# Product Change Notification

**Change Notification #:** 114137 - 04  
**Change Title:** Intel® Dual Band Wireless-AC 8260,  
Intel® Dual Band Wireless-N 8260, SKUs:  
8260.NGWMG.NVS, 8260.NGWMG.S,  
8260.NGWMG, 8260.NGWMG.NV;  
8260.NGWMG.K,  
PCN 114137-04, Product Design,  
Label Update and OTP Update,  
**Reason for Revision: Correction to Label  
Artwork for 8260.NGWMG.NV and  
8260.NGWMG**  
**Date of Publication:** April 18, 2016

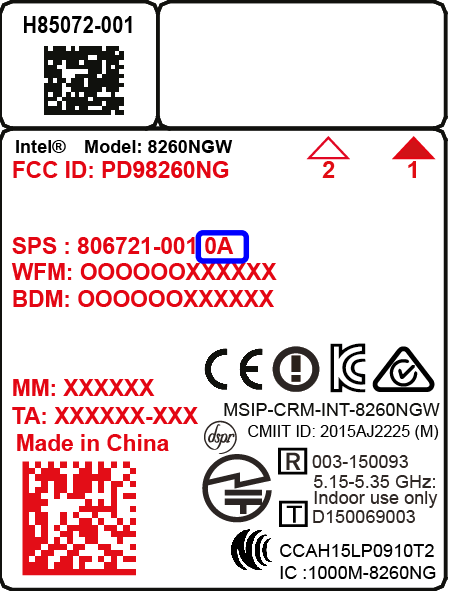
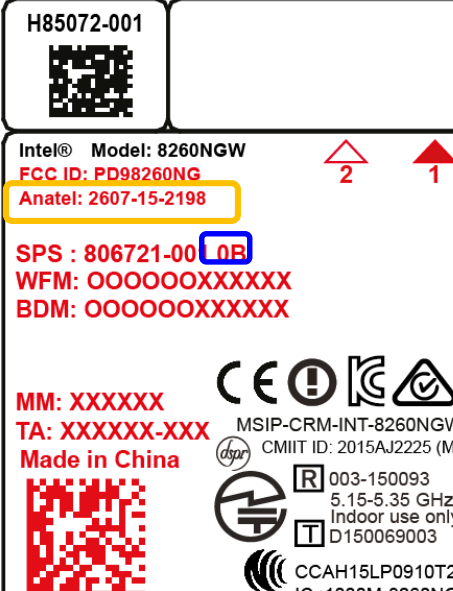
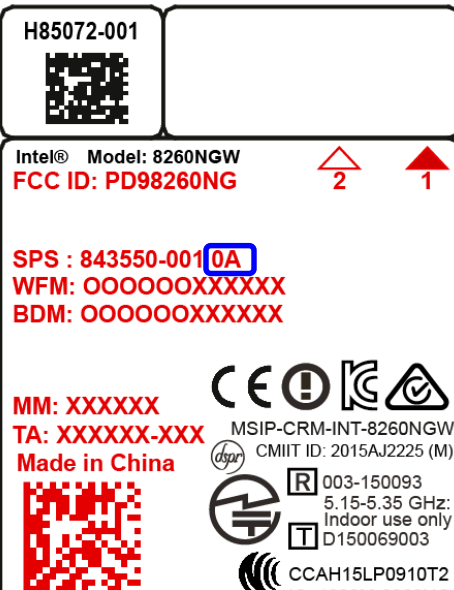
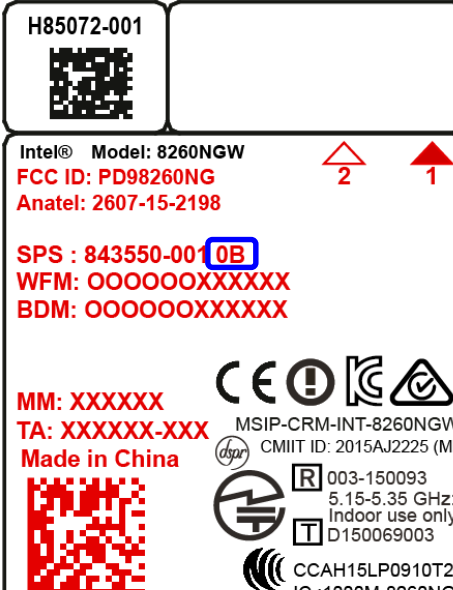
3. Add Argentina Regulatory marking on the box label

B E F O R E	<p><b>XXXXXXXXXX</b></p> <p>VERSION #: XXXXX-XXX</p> <p>MADE IN CHINA WITH PARTIAL FOREIGN CONTENT CARTON #: VVXXXXXXXX</p>	<p><b>MM#: XXXXXX</b></p> <p>PACK DATE: DD MMM YY PACKED BY: XXXXXX</p> <p>BATCH #: CCVVYMDRSS</p>	<p><b>QTY: 100</b></p> <p>1 88334 00140 2</p> <p>9 310779 300005</p>	<p>Intel® Dual Band Wireless-AC 8260 (Model: 8260NGW)</p> <p>D P/N: P P P P P P    REV AX X    HP P/N: XXXXX-XXX Rev: XX</p> <p>PKG ID (3S) VVVVMMMMDDDD####PPPPPP100    T/PN: GTTTTTTTTTT</p> <p>Vendor ID   Loc Id    Mfg Id</p> <p>VVVVJLLLLL    M M M M M</p> <p>PTA APPROVED MODEL</p>
	A F T E R	<p><b>XXXXXXXXXX</b></p> <p>VERSION #: XXXXX-XXX</p> <p>MADE IN CHINA WITH PARTIAL FOREIGN CONTENT CARTON #: VVXXXXXXXX</p>	<p><b>MM#: XXXXXX</b></p> <p>PACK DATE: DD MMM YY PACKED BY: XXXXXX</p> <p>BATCH #: CCVVYMDRSS</p>	<p><b>QTY: 100</b></p> <p>1 88334 00140 2</p> <p>9 310779 300005</p>

4. Add Brazil Regulatory markings (Anatel ID)
5. OTP Changes to fix BT Issues
  - a. OTP Patch to fix BT Device Lost Issue as noted in Intel® Dual Band Wireless-AC 8260 Technical Advisory
  - b. OTP patch to resolve 2 BT Yellow Bang Issues as noted in Intel® Dual Band Wireless-AC 8260 Technical Advisory
